| <b>Subject:</b> | M20 Junction Assessment Review |                          |

Highways England commissioned Atkins to undertake review of the M20, Junction 5 to 8 junction models. The models were developed by Mott MacDonald to evaluate the impact of the Maidstone Borough Local Plan on the capacity of the M20 Junctions 5 through 8.

Atkins has undertaken a high level model review based on Mott Macdonald's M20 Junction Assessment report. The key findings from Atkins' review are as follows:

### 1. M20 Junction 6 (South roundabout) ICD measurement

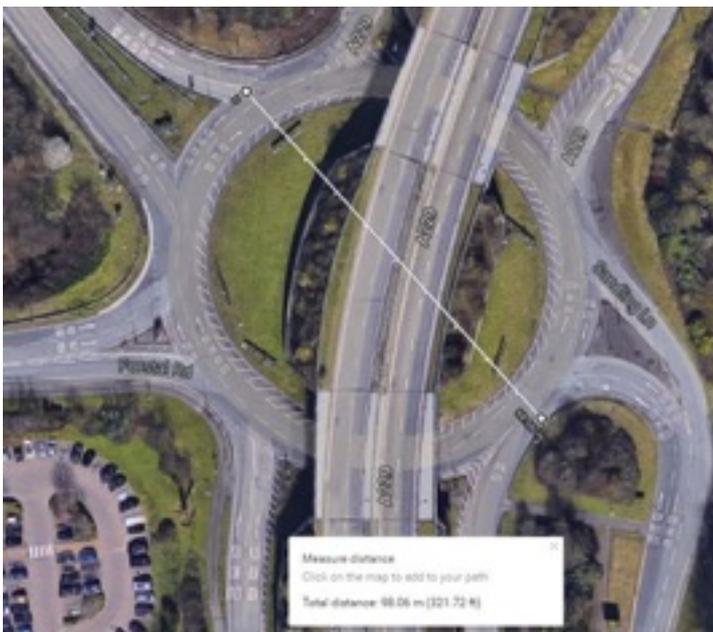
- Inscribed diameter (ICD) for north roundabout should be approximately 87m whereas this is entered as 91m in the model.
- Similarly ICD for the south roundabout should be approximately 98m whereas this is entered as 102m in the model (see Figure 1 for example)
- The entry width measurement for the M20 off-slip is approximately 7m whereas this is entered as 8.14m.
- Lane allocation used in the model needs justification as this does not match with the existing road markings, e.g. at South roundabout – A229 Chatham Road (off-slip) northbound has only one lane for M20 London whereas in model this is entered as two lanes.
